DOCKETED	
Docket Number:	24-OPT-01
Project Title:	Perkins Renewable Energy Project
TN #:	257953
Document Title:	Perkins CEC Data Request Response Set #1 for the Opt-in Application 24-OPT-01 Part 1
Description:	Response Set #1 for the CEC Data Request for the Perkins Renewable Energy Project Opt-in Application 24-OPT-01
Filer:	Emily Capello
Organization:	Panorama Environmental, Inc.
Submitter Role:	Applicant Consultant
Submission Date:	7/23/2024 11:31:00 AM
Docketed Date:	7/23/2024

**California Energy Commission
Perkins Renewable Energy Project
CEC Data Request Response Set #1 for the
Opt-in Application 24-OPT-01**

CEC Data Request Response Set #1 for the Opt-in Application 24-OPT-01

Figure 6 Authorizations and Leaseholders on BLM Lands Mapbook Overview

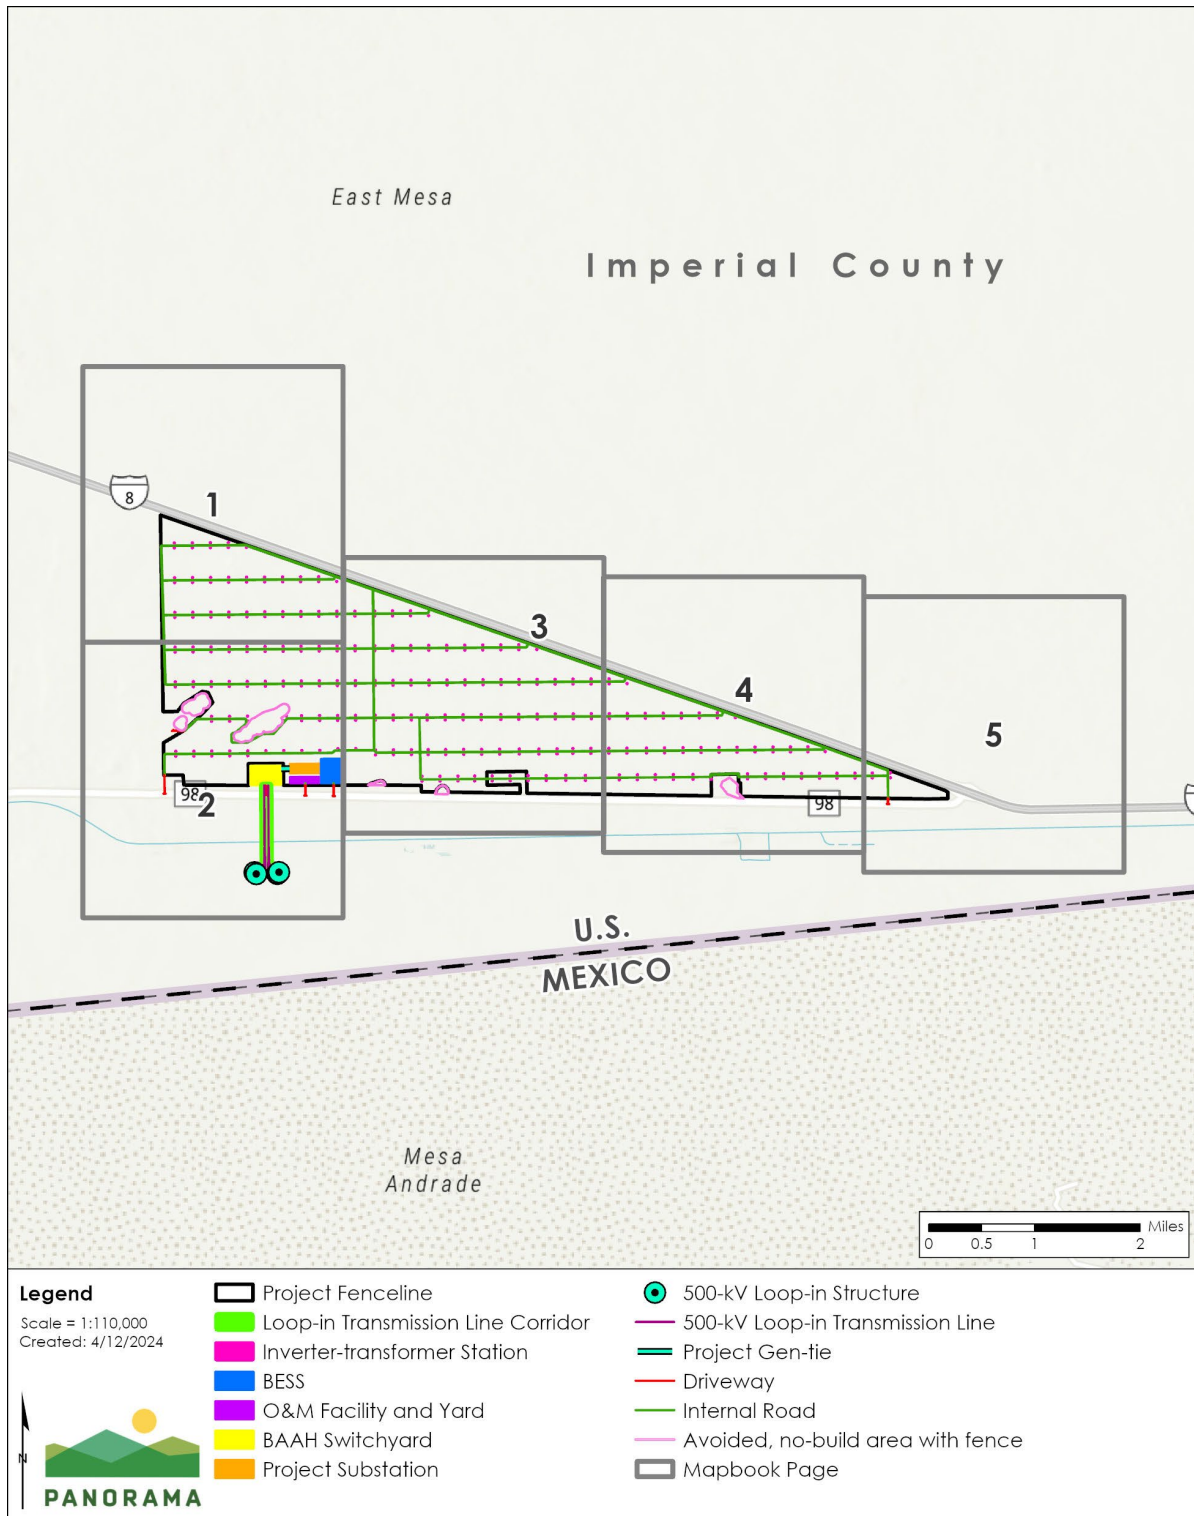
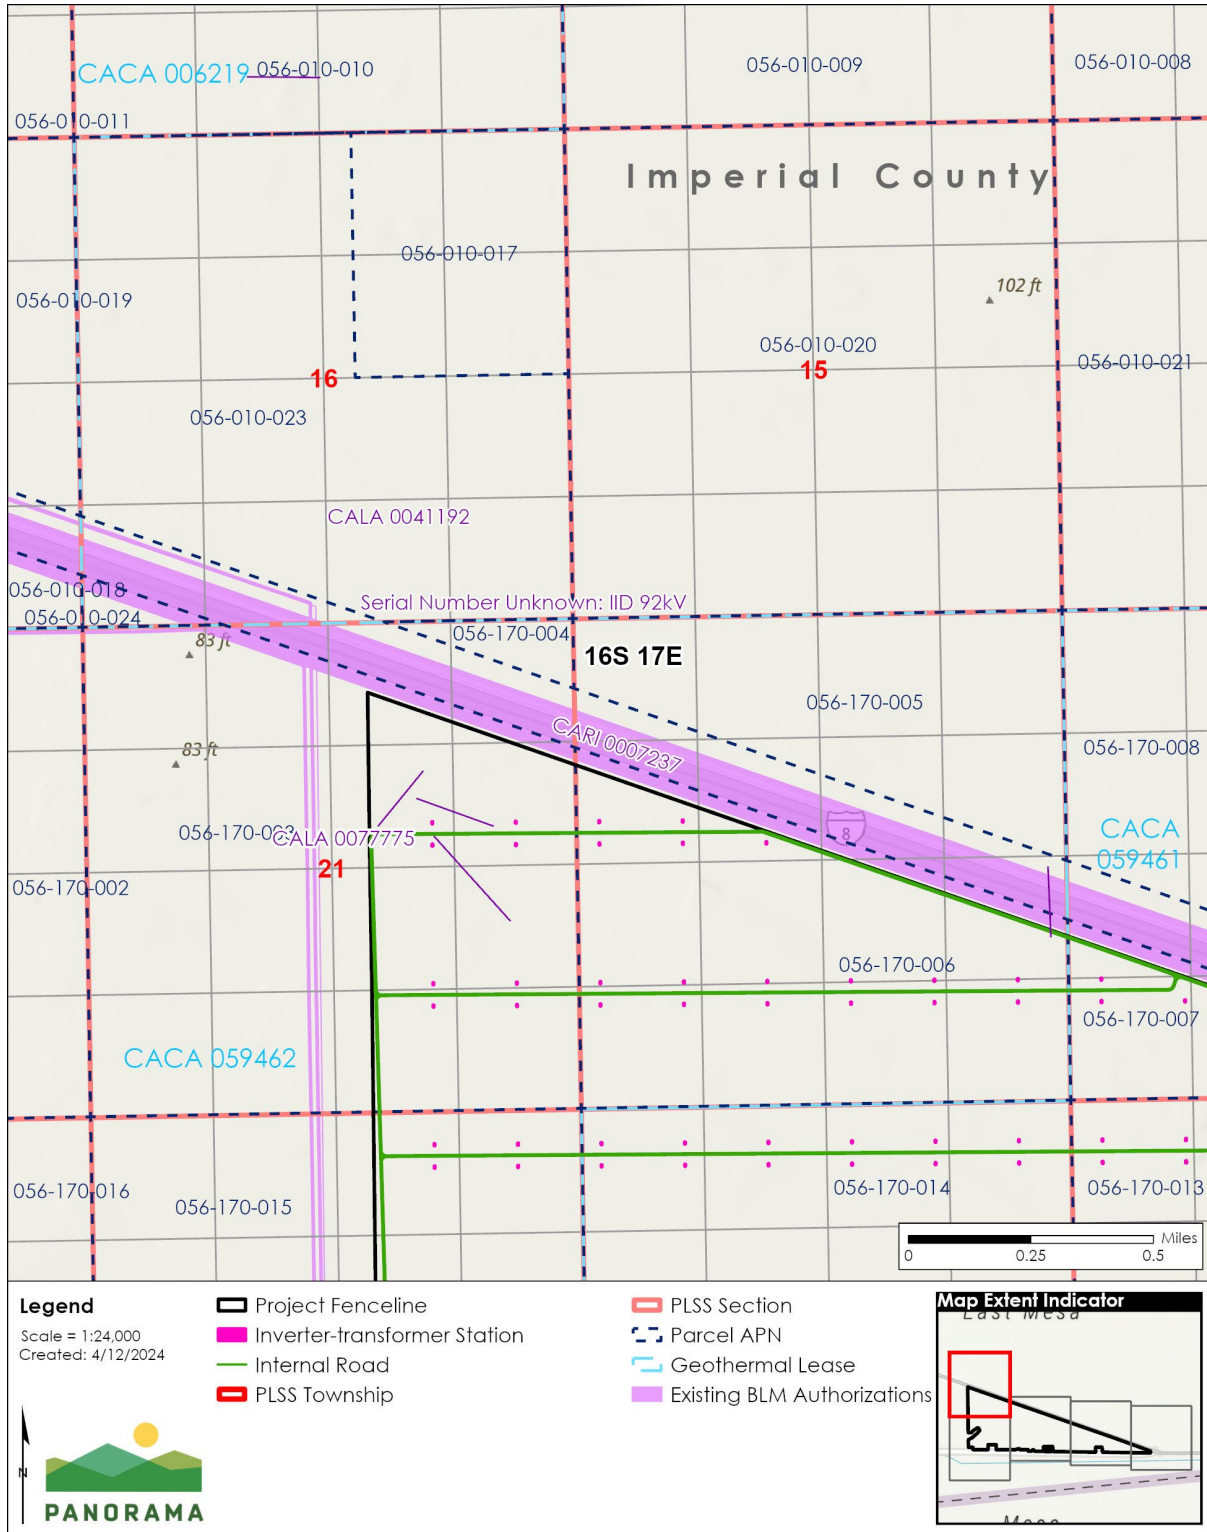
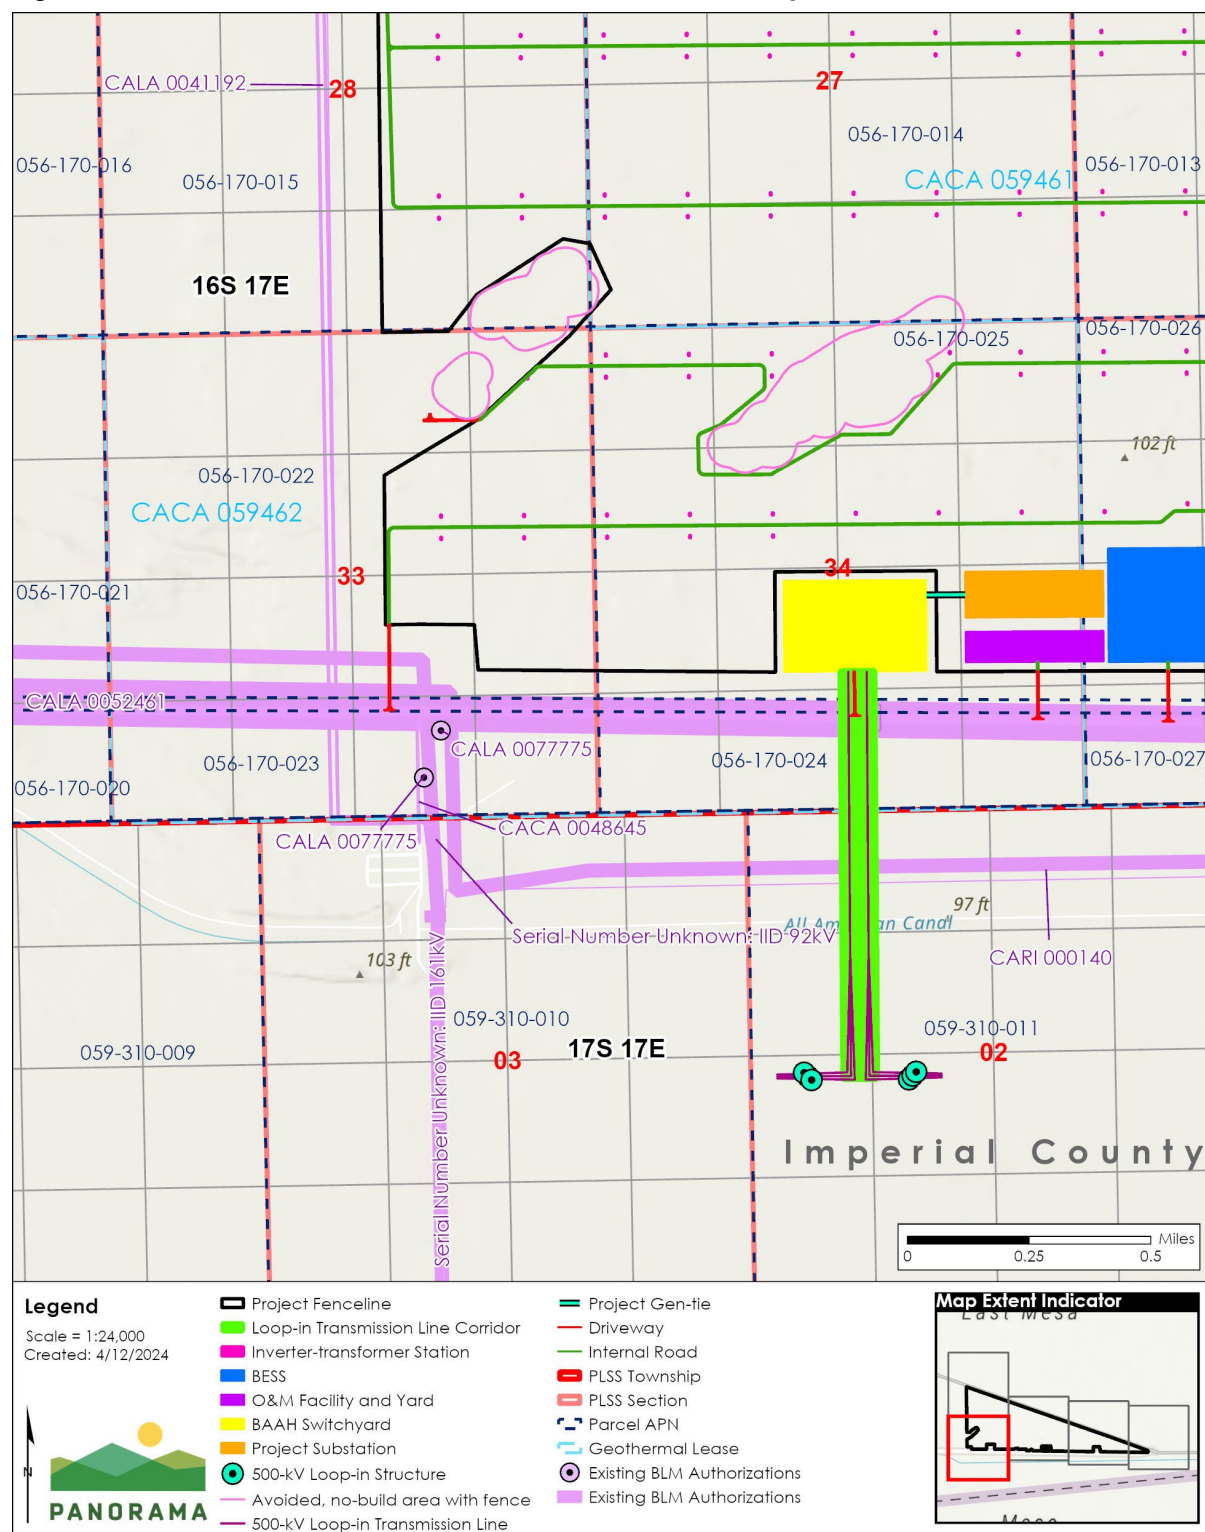
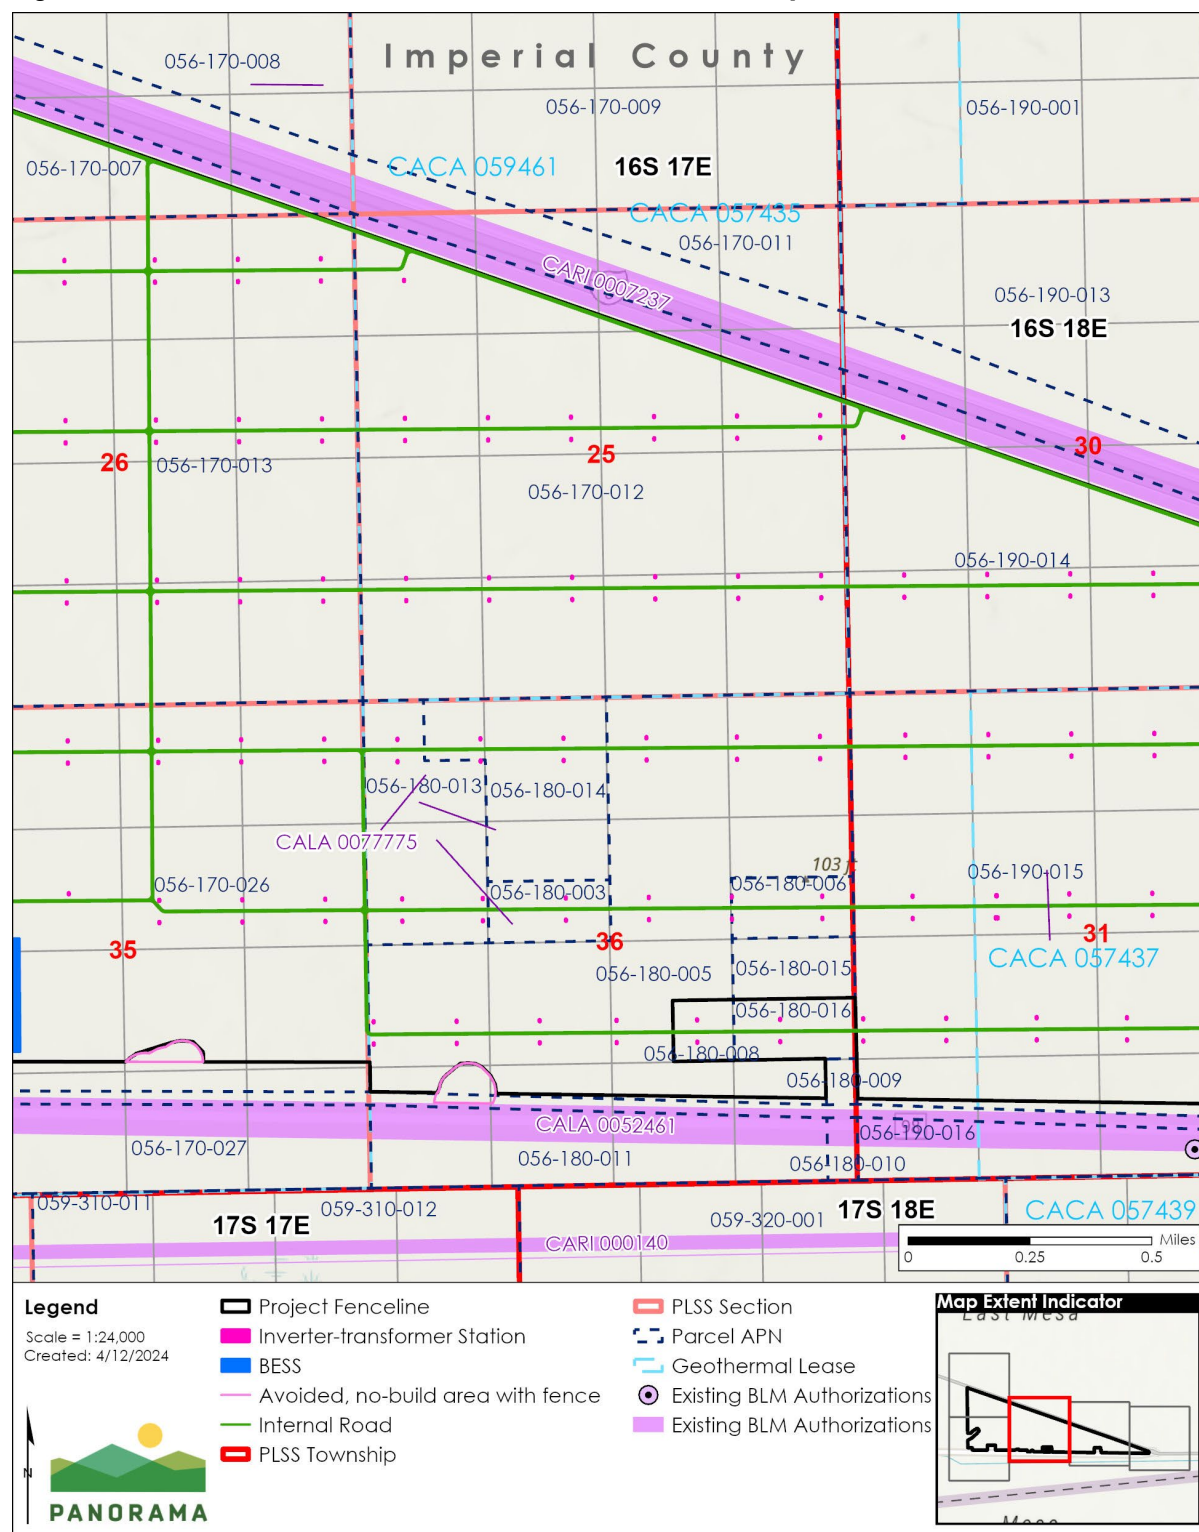
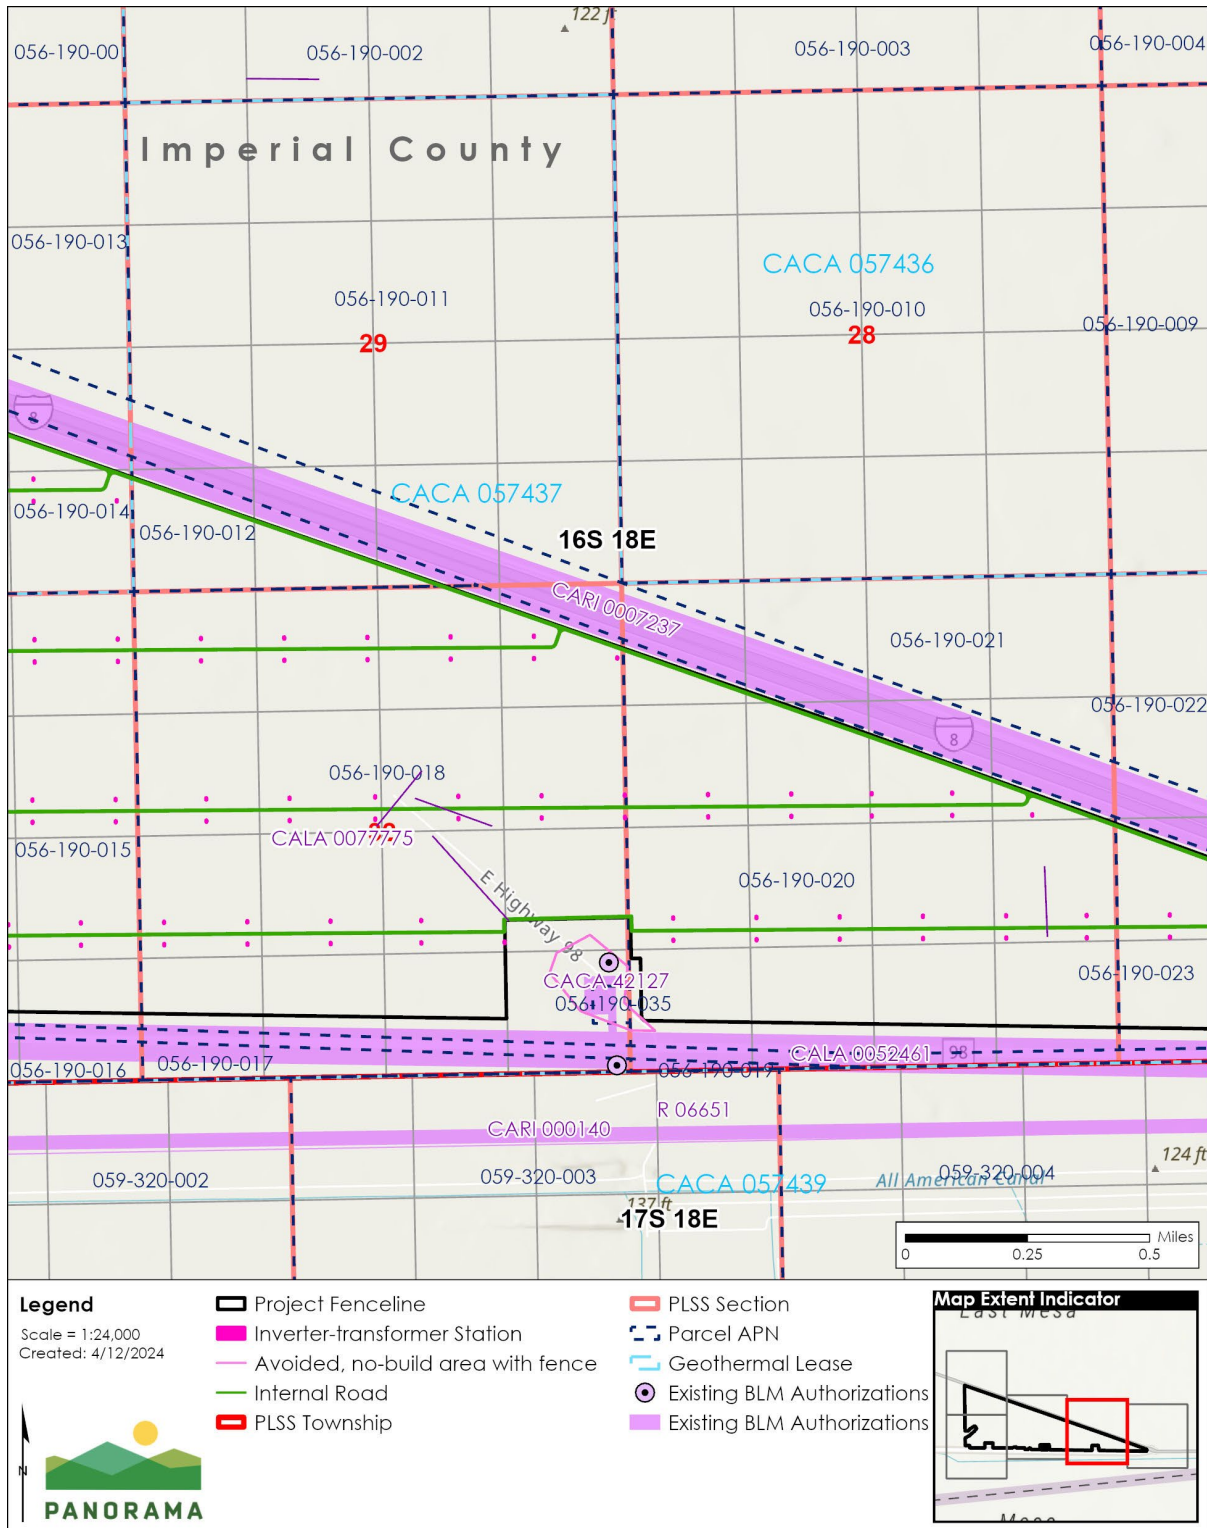
DR PD-4: Please identify and label the county on each map (Figures 6 to 11), please identify and label the county-international border on applicable maps; and please identify and label the township, range and section(s) in each figure title (Figures 7 to 11).
